NORTH ANNA COL

**DATA REPORT REV. 0
JANUARY 23, 2007**

**DOCUMENTATION OF TECHNICAL REVIEW
SUBCONTRACTOR WORK PRODUCT**

SUMMARY OF REVISIONS REV. 2 CPT REPORT (table 1 only revised and issued)

Site: NORTH ANNA COL.
Location: CPT-907 |

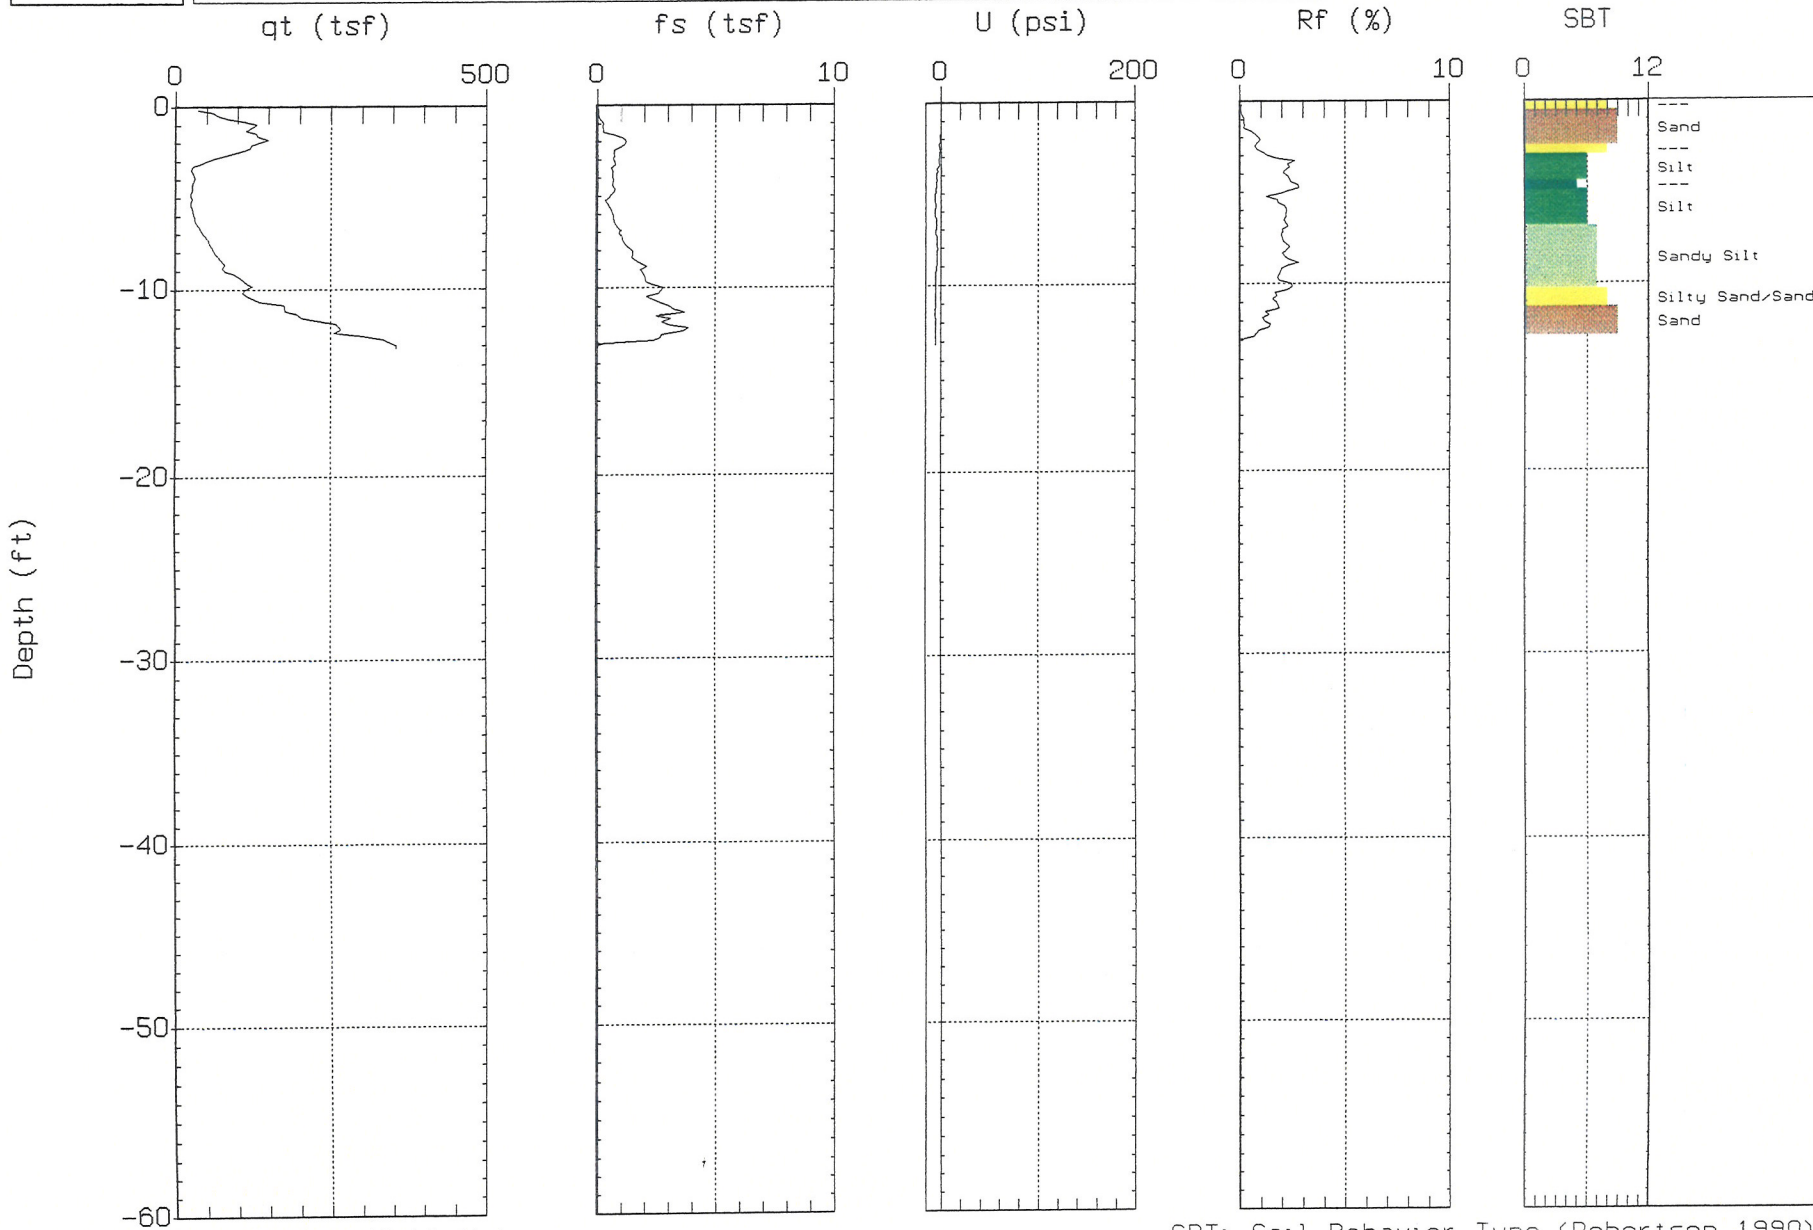
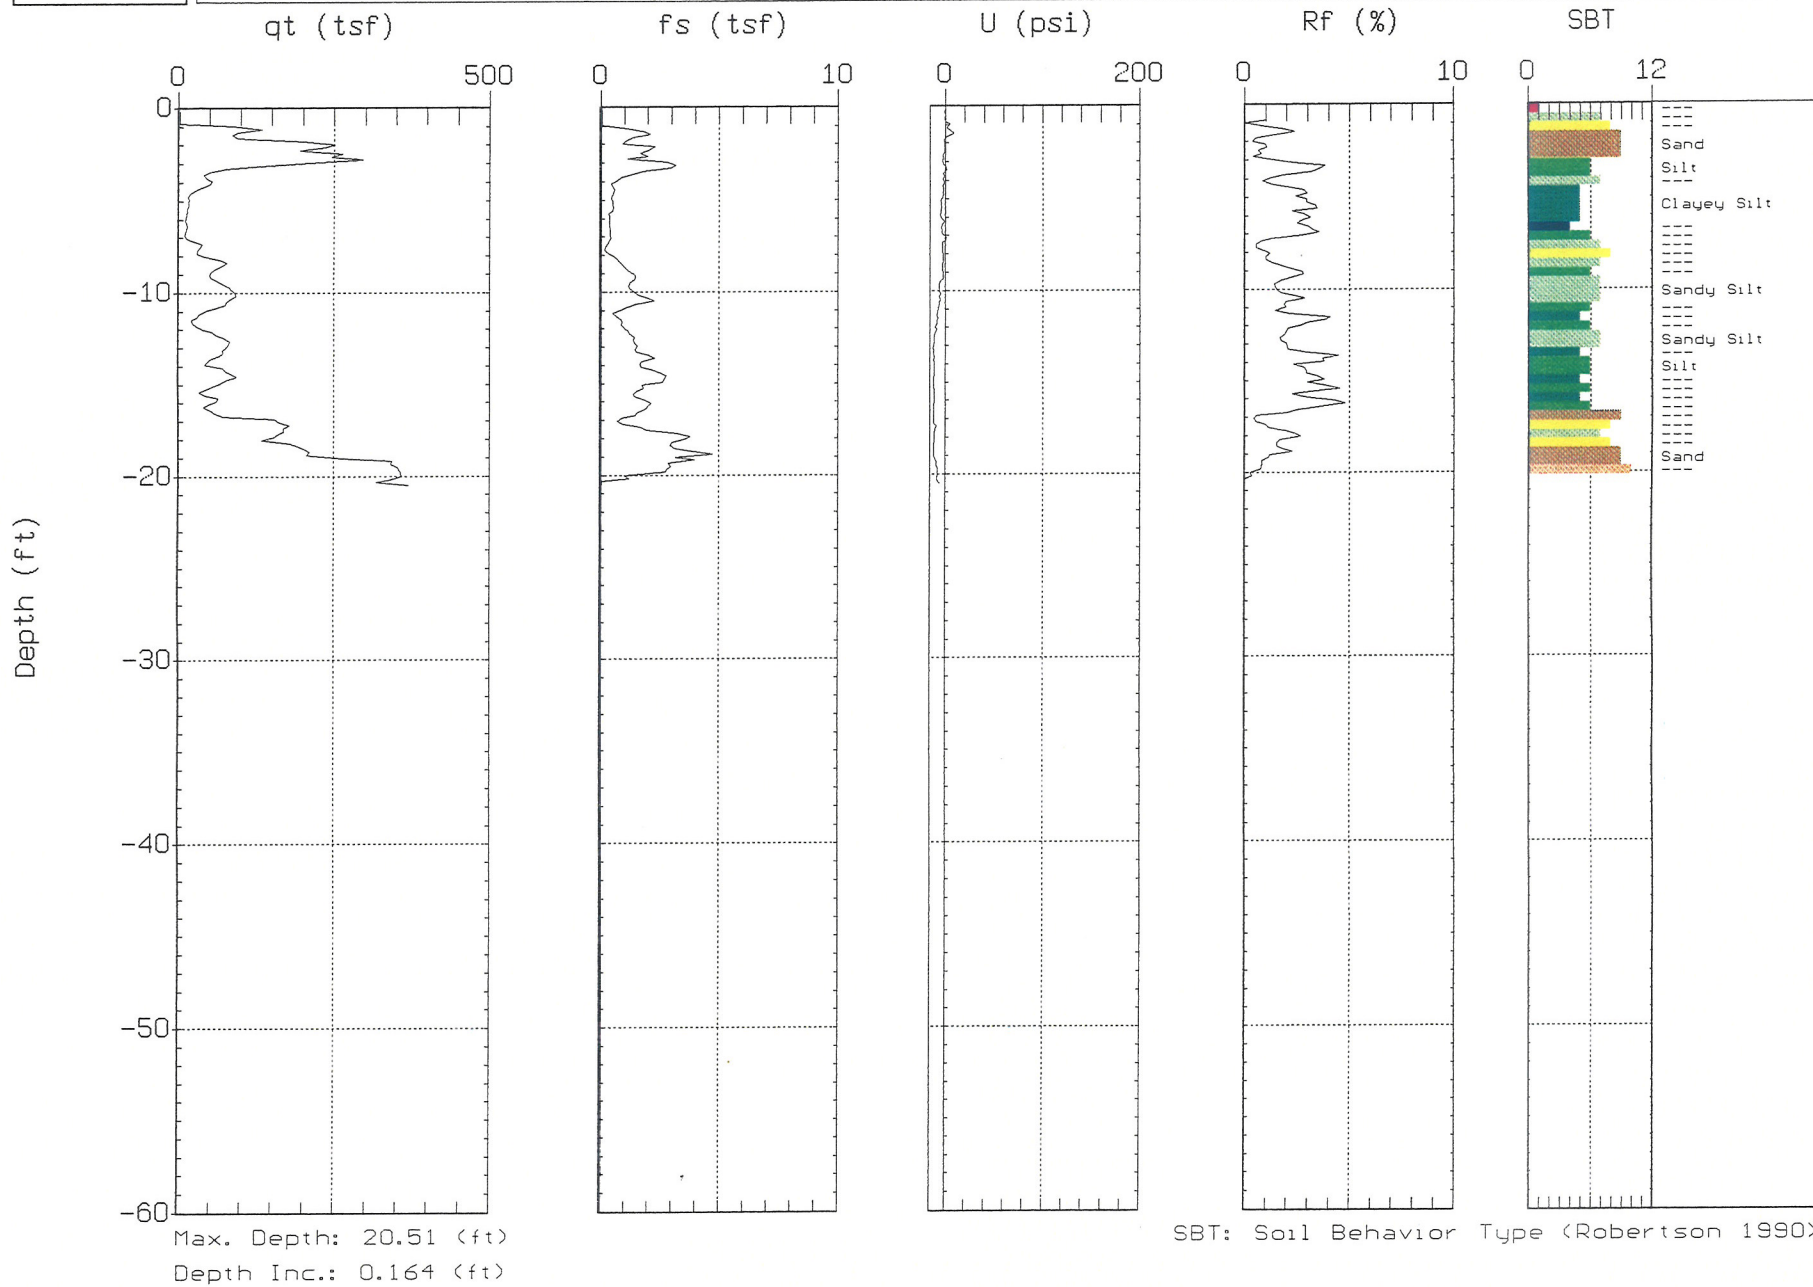
1. Cone Penetration Test Sounding Summary – Table 1. Replaced table to correct mis-numbering of CPT-907 and CPT-917.
2. Plots for correct CPT-907 inserted. No plots for CPT-907 were included in the original report.
3. Replaced plots for CPT-917 with correct plots.
4. Removed plot of Pore Pressure Dissipation Test labeled CPT-907 and replaced with plot correctly labeled CPT-917.
